December 13, 2024

Rhys Harrington
Senior Capital Project Coordinator
Planning and Capital Development Branch
City of Seattle, Seattle Parks and Recreation
100 Dexter Avenue North
Seattle, WA, 98109

For the purposes of this letter, TCLF’s comments concern the April 2024 60% Briefing document.

Figures 1-2: The impacts of the proposed structures and hardscape on Seneca Plaza are evident in contrasting the proposal [right] with as-built image of the original design (see *Process No 4: Lawrence Halprin*) [left]

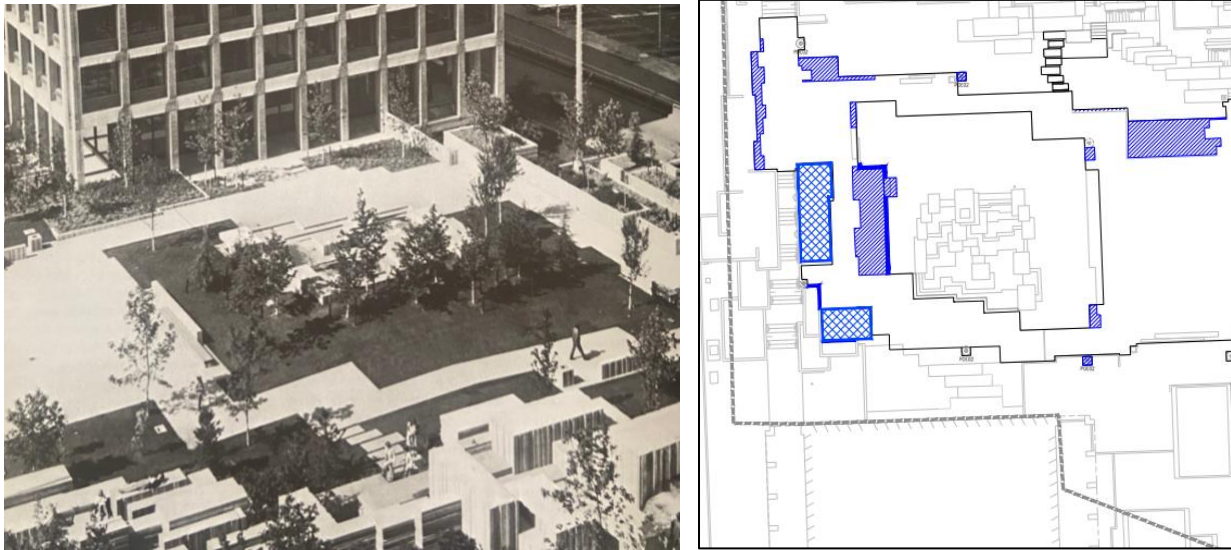
Similarly, the removal of the perimeter tree/vegetative buffer and replacement with the multiple bathroom/“conciierge” structure fundamentally alters visual and spatial relationships and removes an important design feature in the plaza. Halprin said of trees in his 2008 [oral history](#) with TCLF: “they add a sense of scale and a sense of well-being and a sense of security and on-going-ness that always helps a landscape project.” We do recognize that structural loading and safety have been identified as an issue that requires mitigation, but according to page 58 of the April 2024 document, the tree buffer removal is not related to structural loading and/or safety, but only to “change of use.” This is an adverse effect that should be avoided.

Because of the inconsistent use of dimensions throughout the April 2024 documents, it’s difficult to thoroughly assess the impact of the proposed changes to Seneca Plaza and elsewhere. For example, the width and length of the multiple bathroom/“conciierge” structure is provided, **but not the height**. In fact, the only approximation of the massing of this significant addition is the rendering on Page 26. What is the height of these structures relative to the fountain? Similarly, a portion of the unpaved apron around the fountain is proposed to be paved and a seat wall with a “stepping platform” would be inserted. However, there’s no indication of the dimensions of this expanded paved area and the visual and spatial impacts caused by the removal of the tree/vegetative buffer and the introduction of the new seat wall.

Unlike anywhere else in the current rehabilitation proposals, the significant addition of structures, seat wall, and hardscape to the west/northwest of the Seneca Plaza fountain (the lawn apron here appears to be reduced by more than two-thirds along the western edge, in contrast to its northern and eastern lawn borders), significantly impacts the fountain’s integrity of setting, which is the signature (and iconic) design element in the plaza, and has an adverse effect on the landscape language that is introduced here by Halprin as part of his cohesive choreographed movement that sets the stage as one moves toward the Canyon Fountain.

Figure 3: Pedestrian-scale light standards in Field Operations design for the Seattle Waterfront. Here fixtures perform their role while receding.

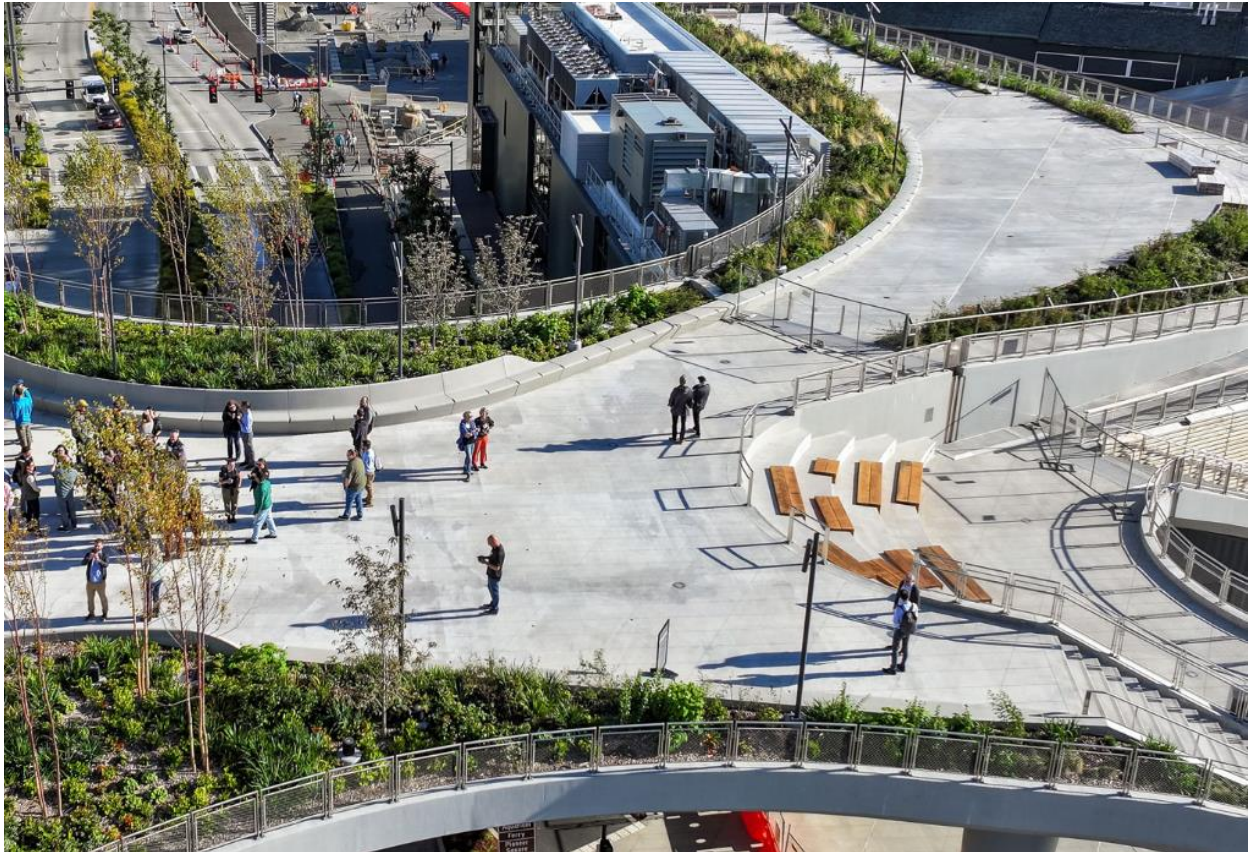
Rather than relating to the existing design (a tenet expressed by Halprin in a January 1969 *Architectural Forum* article) these new elements read as superimposed or an imposition on the original. The new lighting, for example, neither recedes nor complements the existing lighting and site design. Rather, it is discordant and competes for attention. By contrast, see the image (below) of the lighting that has been installed at Seattle’s Waterfront Park, designed by Field Operations, which recedes and does not call attention to itself.
